ARCHITECTURAL REVIEW BOARD
CITY OF FREDERICKSBURG, VIRGINIA
AGENDA
September 12, 2016
7:00 P.M.
COUNCIL CHAMBERS, CITY HALL

TO: ARCHITECTURAL REVIEW BOARD
FROM: Kate Schwartz, Historic Resources Planner
DATE: August 8, 2016
SUBJECT: Certificate of Appropriateness for demolition and new construction at 100 Hanover Street
1st review for demolition and site planning, scale, and massing

NEW BUILDING at 1 HANOVER STREET
PLANS
FREDERICKSBURG, VIRGINIA

100 HANOVER STREET
ELEVATIONS
FREDERICKSBURG, VA

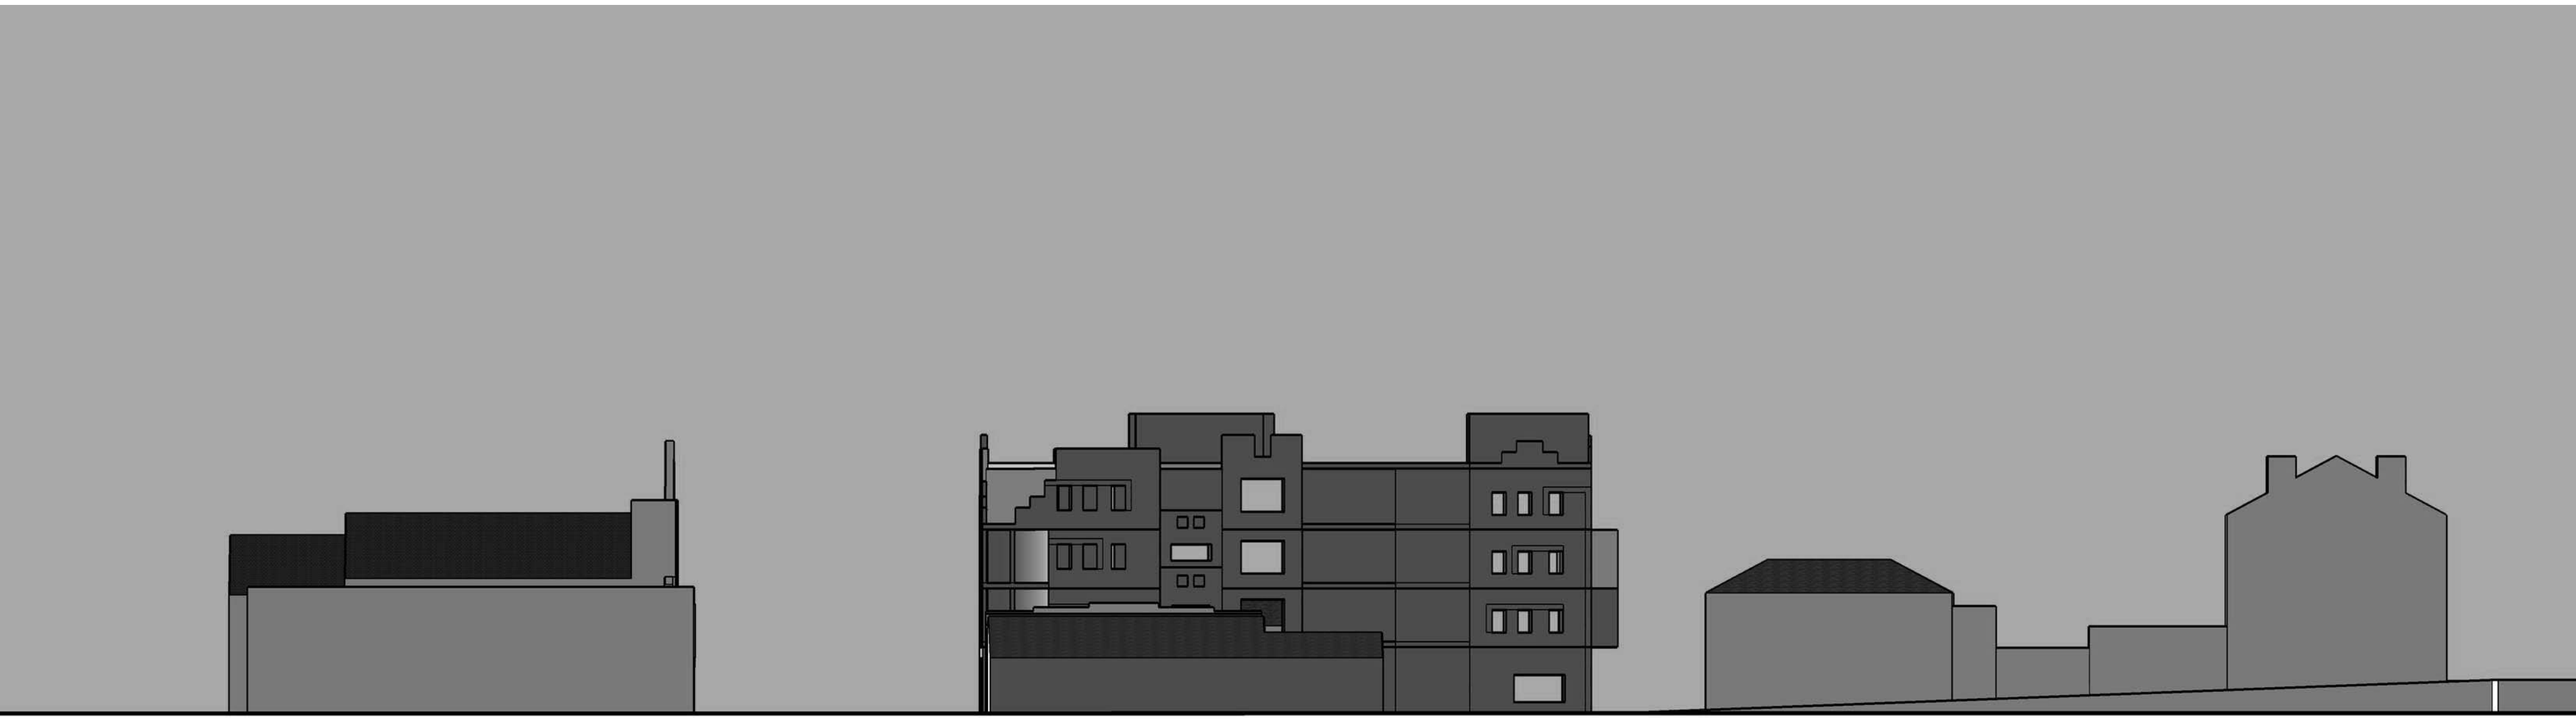
Materials and details will not be evaluated until the site planning, scale, and massing have been approved by the Board; however, the applicant has provided preliminary information to assist in visualization of the proposed building. The body of the building will be brick, with textured brick used for details and potentially the ground floor. Areas that are stepped back from the primary wall plane will be clad in an alternate material, potentially wood. Railings will be metal, with some consisting of cables and others a picket style. The condo levels will have operable windows.

The site planning, scale, and massing meet the standards and guidelines for the Historic District and approval is recommended. Architectural details, including windows, doors, storefronts, cornices, wall surfaces, materials, and other elements will be considered at a second public hearing. Compatibility with the character of the District can be increased through these additional elements, and items that the Board and applicant may wish to address include:

- Clear delineation of the ground floor and storefronts through materials, coloration, and/or the addition of a cornice or other physical element
- Variations in the color and materiality of bays to provide clear differentiation and mitigate the impact of the building's scale
